**Nomination Form  
Anadromous Waters Catalog**

Anadromous Waters Catalog Number of Water Body 247-60-10276

**~ADD new AWC Stream #247-60-10276 with COHO salmon REARING.**

**From:** [Buza, Josh](#)  
**To:** [Giefer, Joe \(DFG\)](#)  
**Subject:** RE: Question about Nom #24-792 - new stream with Coho salmon rearing & barrier identified  
**Date:** Monday, August 12, 2024 10:08:58 AM

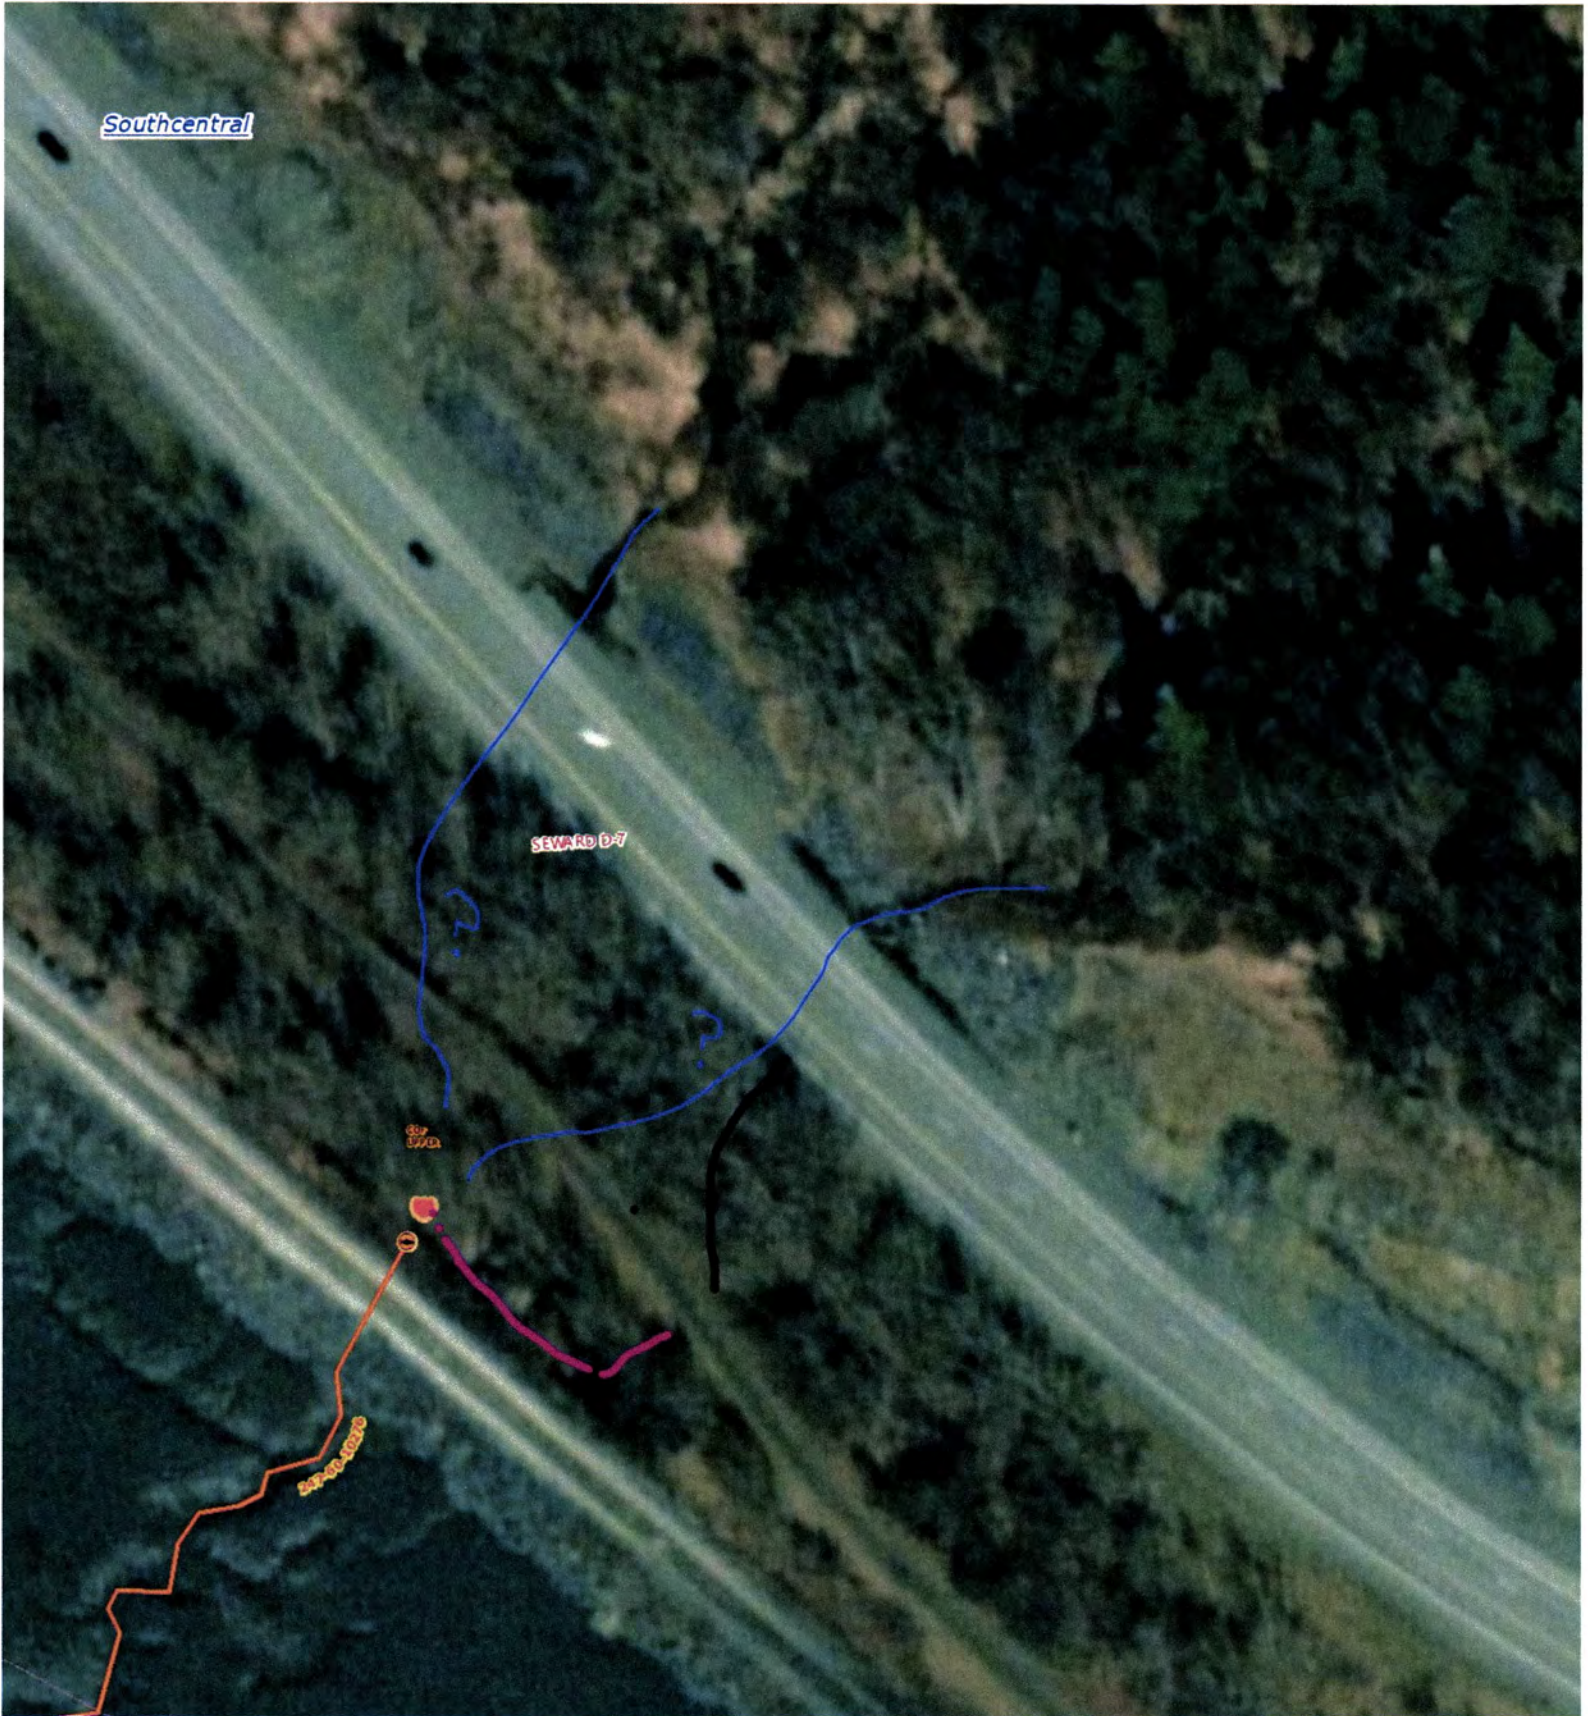
Quick question came up during the review about the barrier identified in the attached nomination.

I just want to clarify whether there was an actual stream channel that visibly continued up a steep gradient which was subject to a gradient barrier, or was it more of a dispersed surface flow collecting at that location to start the beginning of this small water body. Did you happen to take any pictures looking up-channel at this location?

Basically we mark barriers to fish passage that block fish from using upstream habitats, but we don't mark the upper extent of what would generally be considered the river bed because its going up the side of a mountain or other steep terrain. Alternatively did you investigate upstream by the road? Is

there a culvert passing this water under the Seward Hwy? That would also support identifying the barrier here? ( I don't have any hydrography data here so I'm just guessing, examples in attached map). Any additional notes or details you might recall might be helpful.

Thank you for the clarification. I should have said that it is likely unsuitable habitat and not a barrier to fish passage. Unfortunately I do not have any photos upstream. There is a visible channel that has a steep gradient (varying between approximately 20 to 40 degrees) approximately 10 feet upstream of where the trap was set. The upstream channel was narrow (1-2 ft). From what I recall based on the banks of the stream bed, the steep gradient area probably couldn't hold more than 3-5 inches of water. The stream channel follows parallel to the railroad for approximately 25 feet then heads perpendicular to the railroad at a less steep gradient toward the trail/highway. I believe there was a culvert underneath the trail but I'm unsure about the highway. See the attached photo. Red is what I'm sure of, black is what I would assume based off the aerial imagery.
